Project Name: Gier Park - HVAC

Project No.: 221125-050

This Addendum is issued to inform the bidders of modifications in the scope of work being bid for this project.

**END OF ADDENDUM NO. [#2]**

**FIRST FLOOR POWER DEMOLITION PLAN - UNIT 200**  
SCALE: 3/32" = 1'-0"

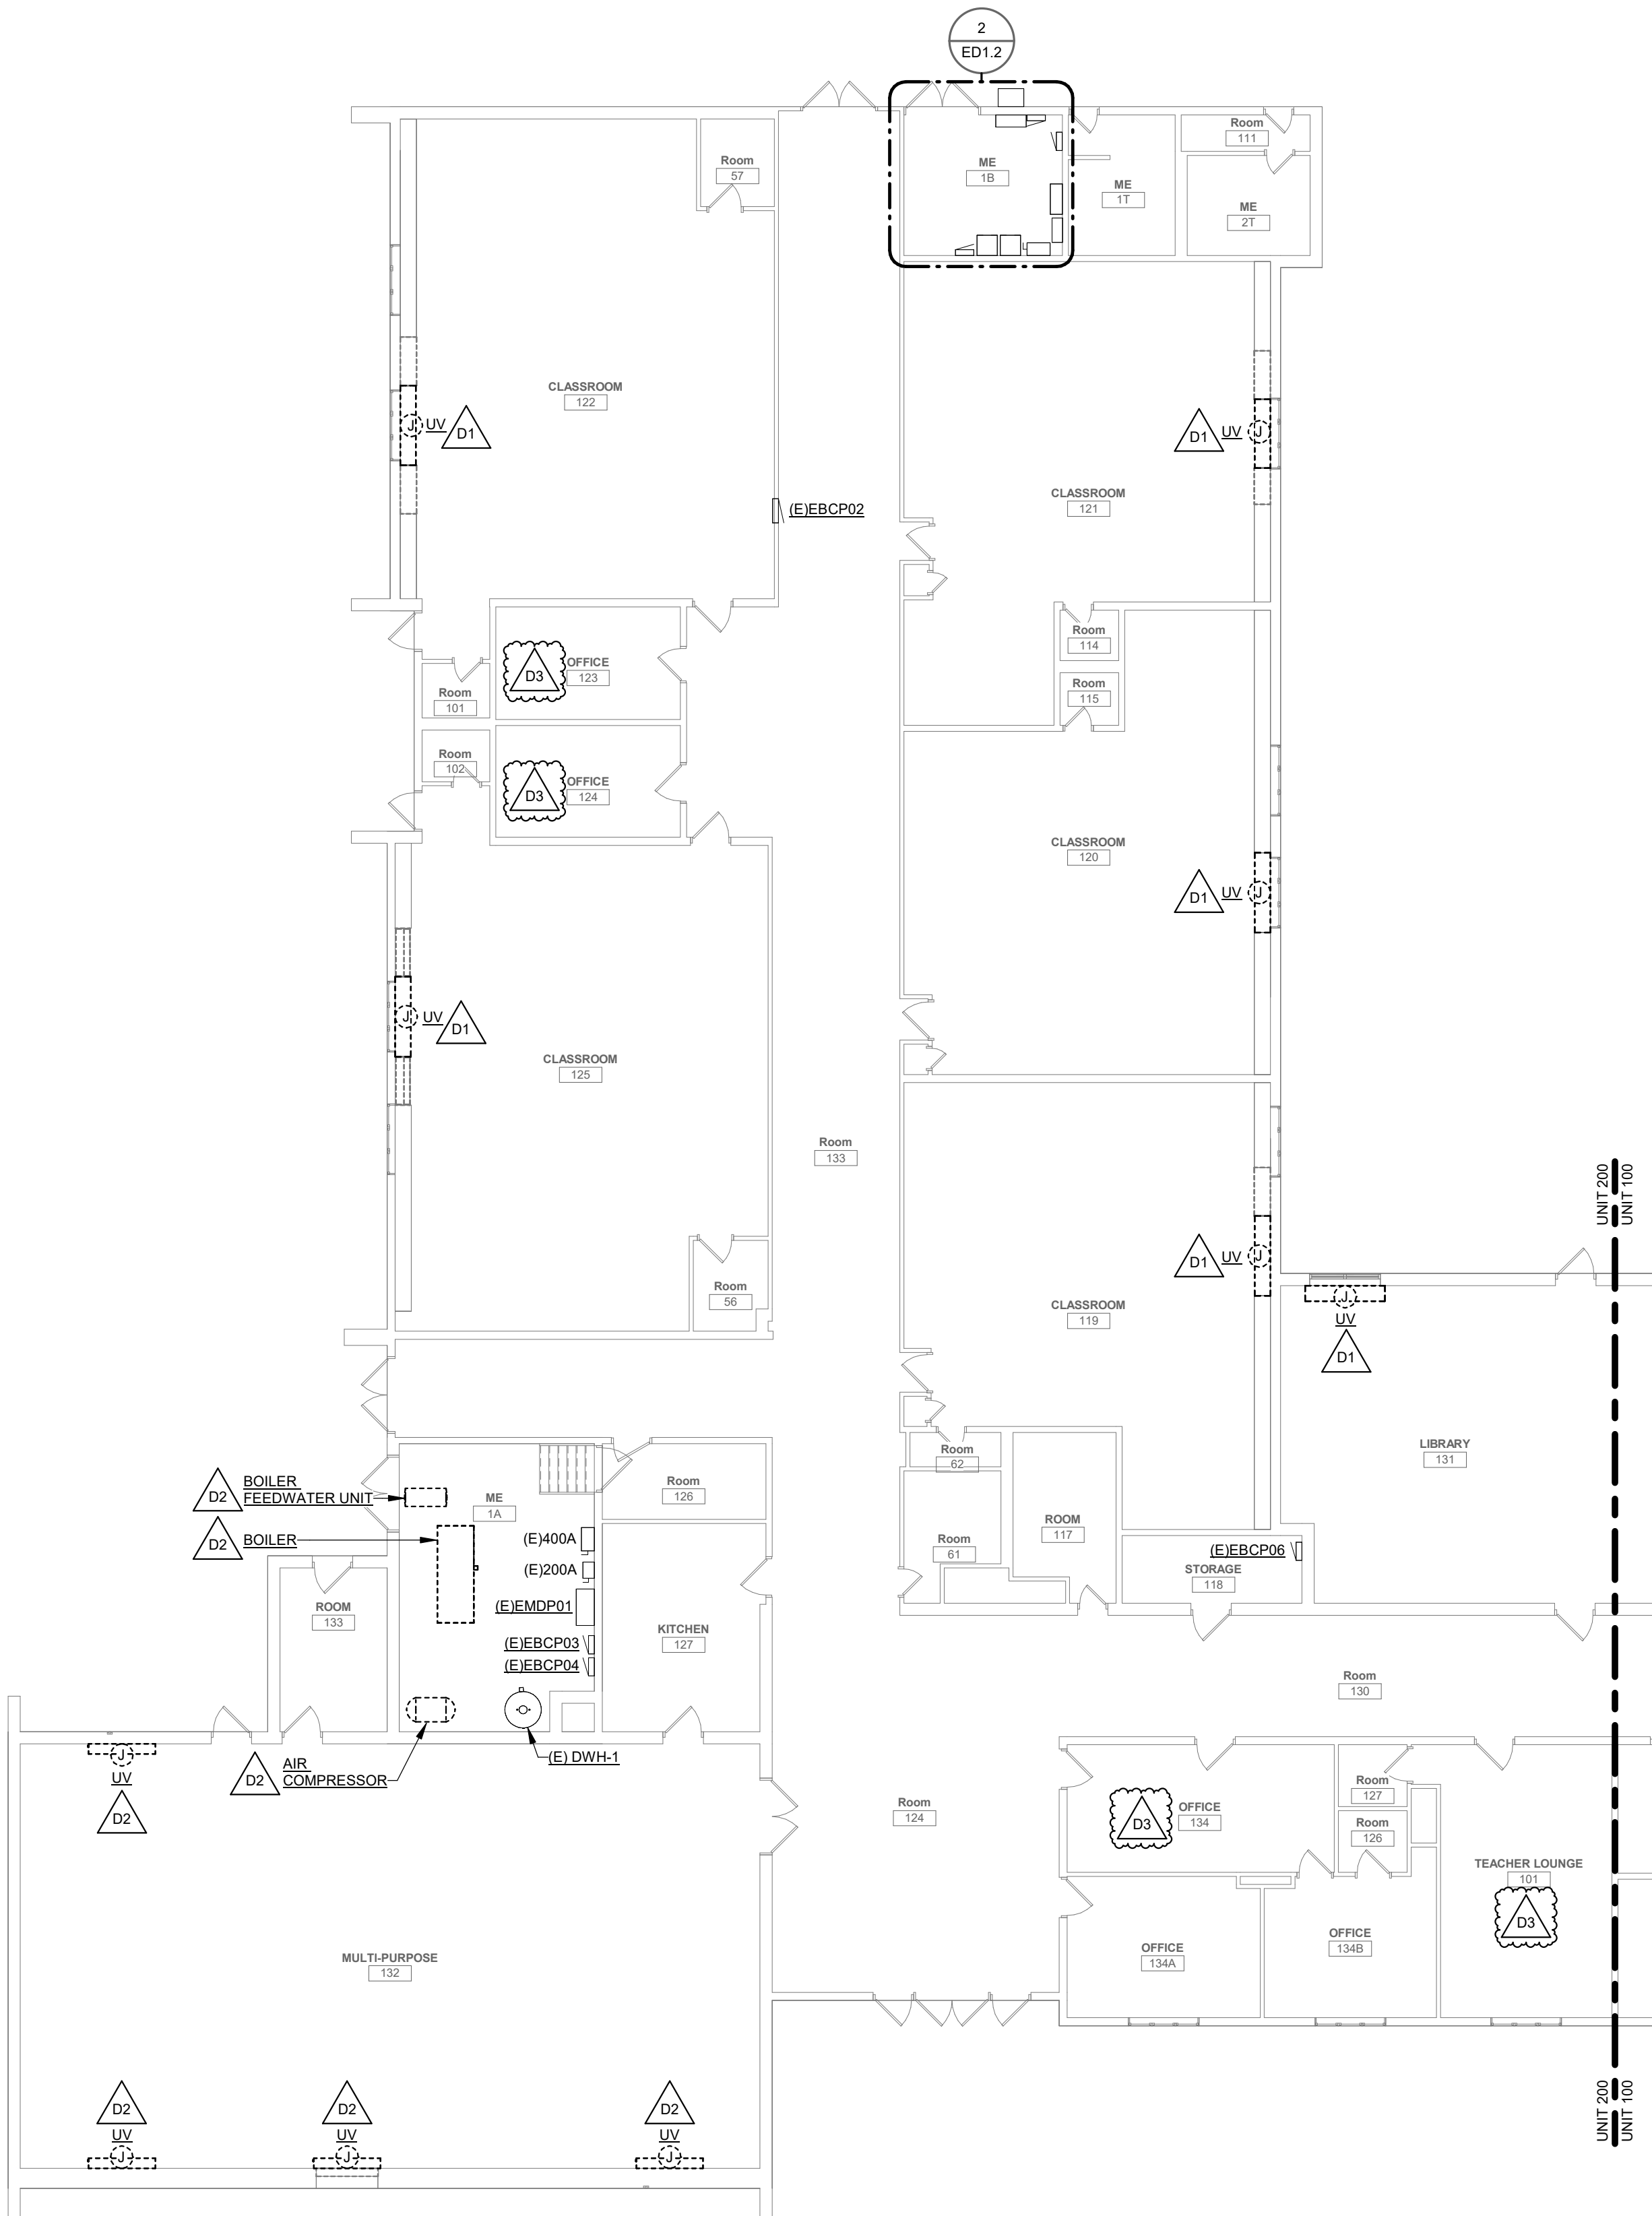
- Added keynote D3.
- Added keynote D3 to office areas where indicated.

**FIRST FLOOR POWER PLAN - UNIT 100**  
SCALE: 3/32" = 1'-0"

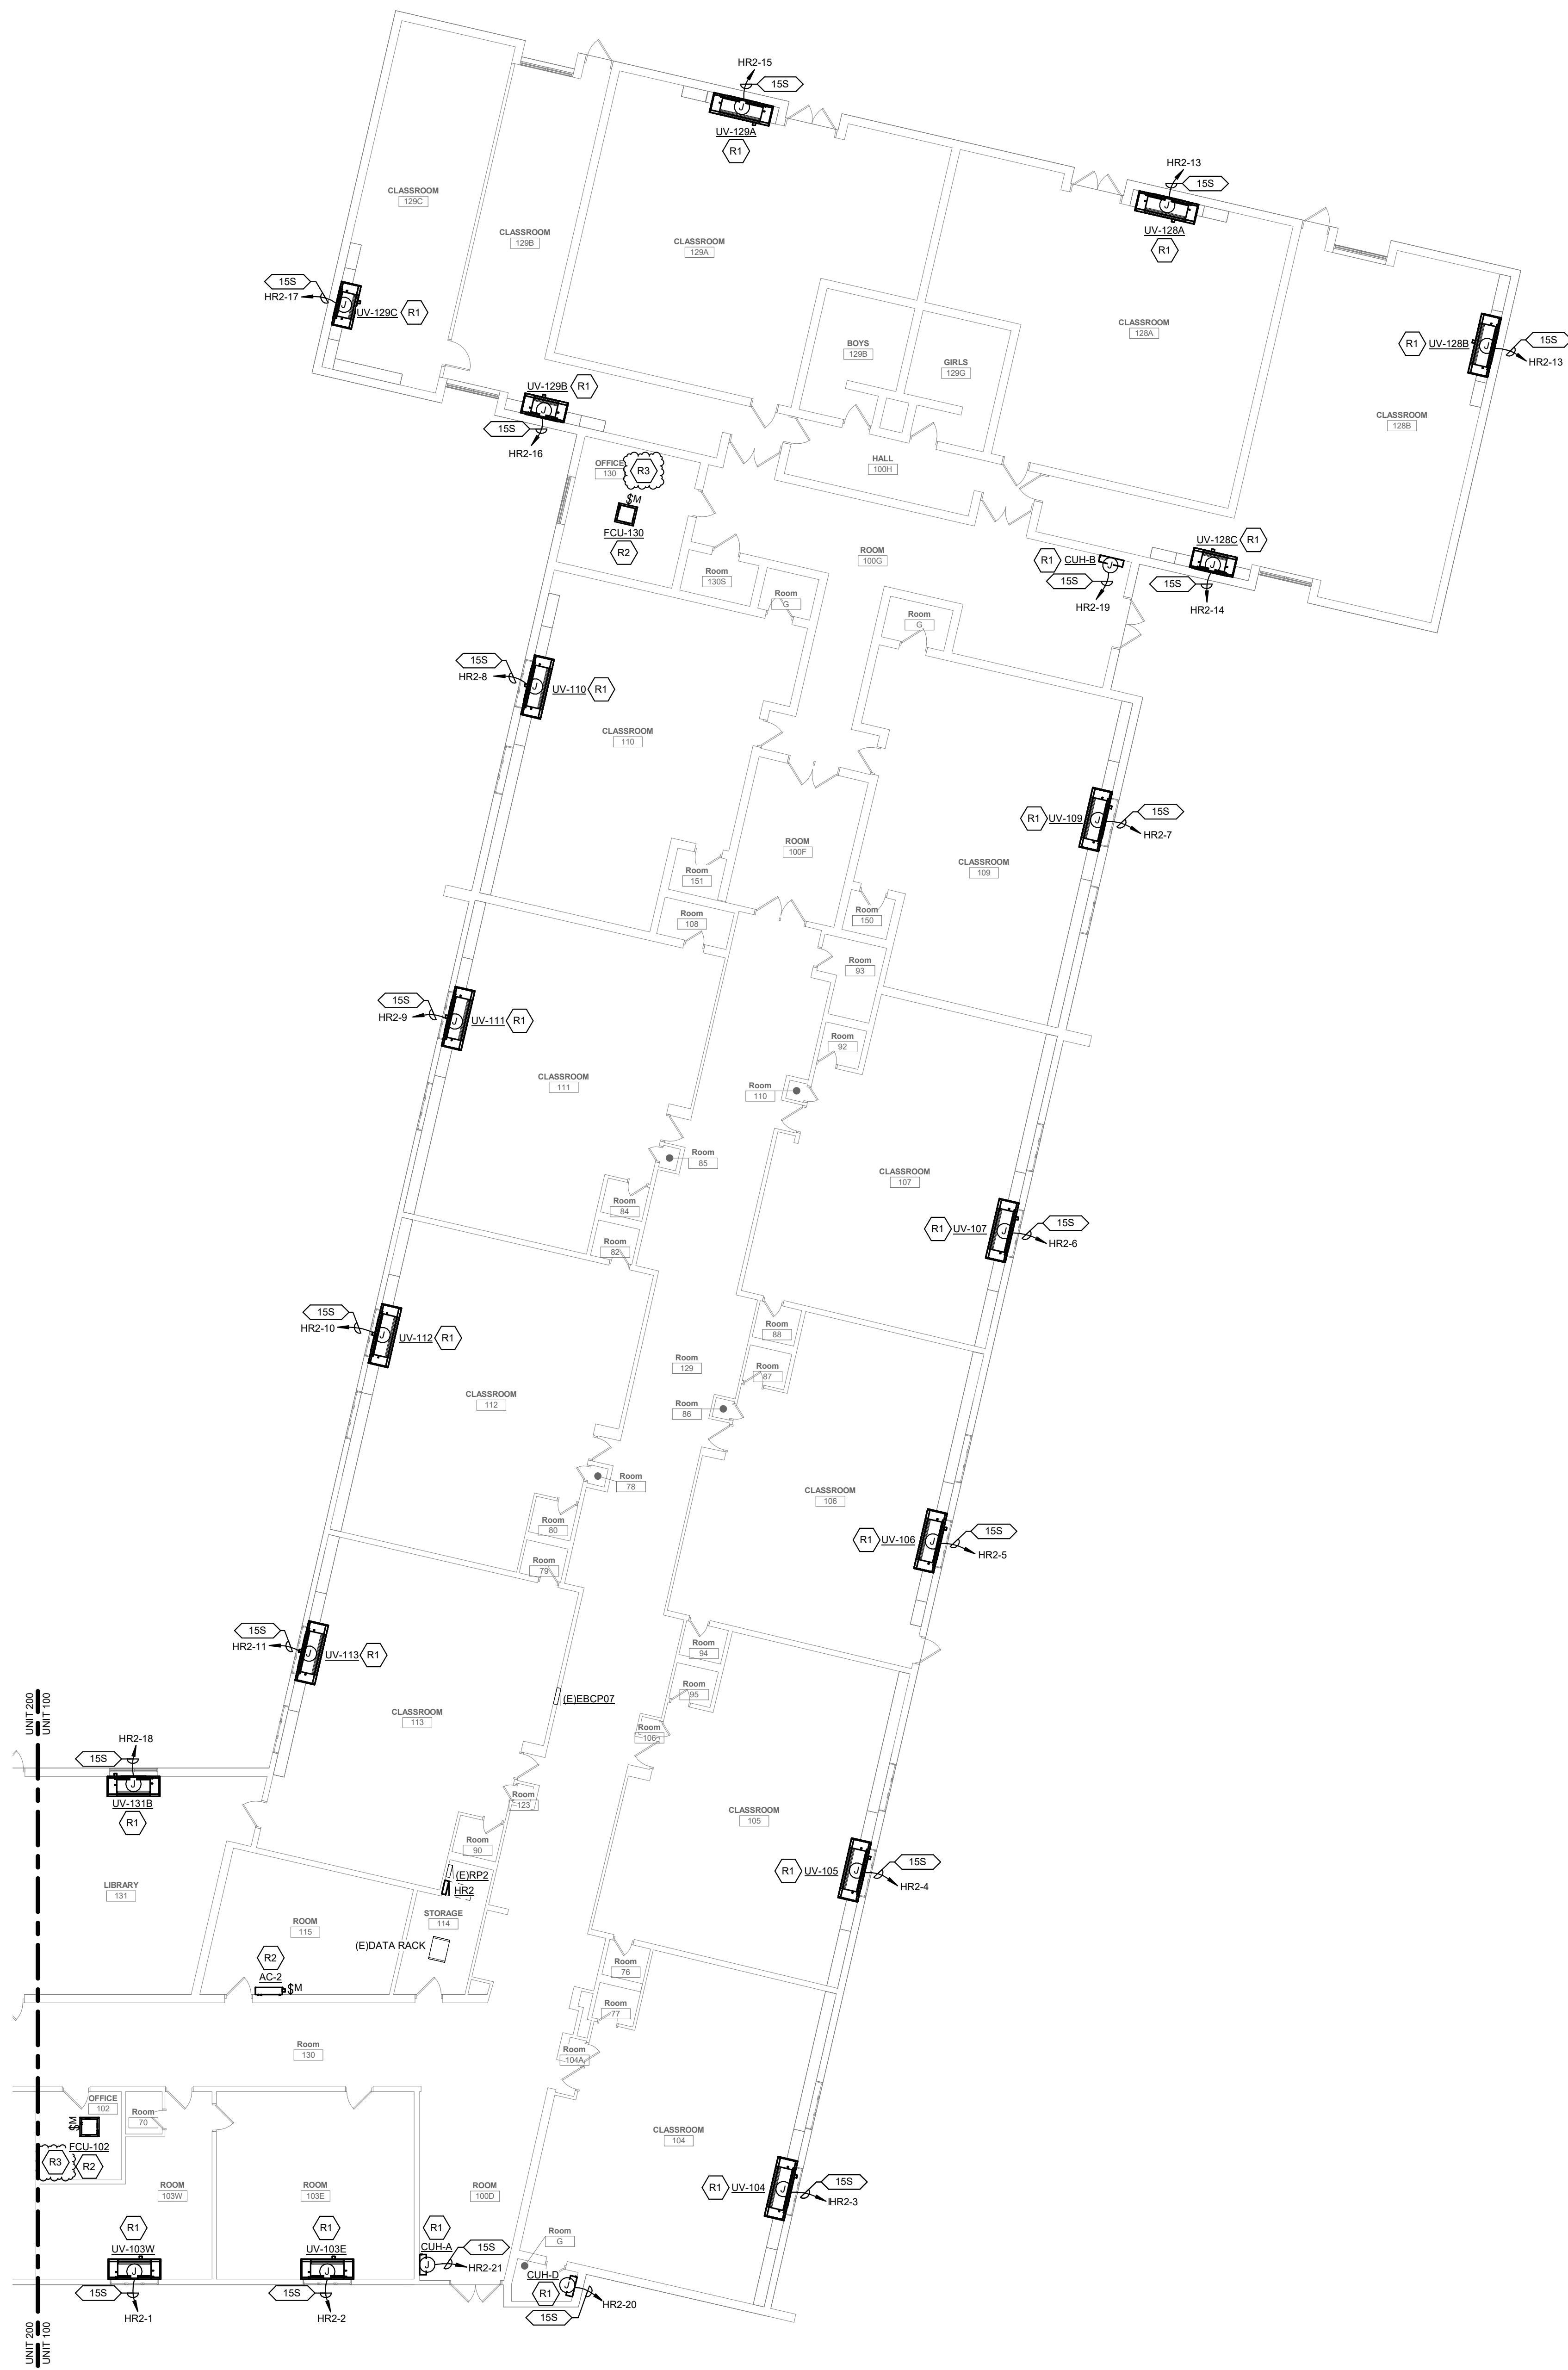
- Added keynote R3.
- Added keynote R3 to office areas where indicated.
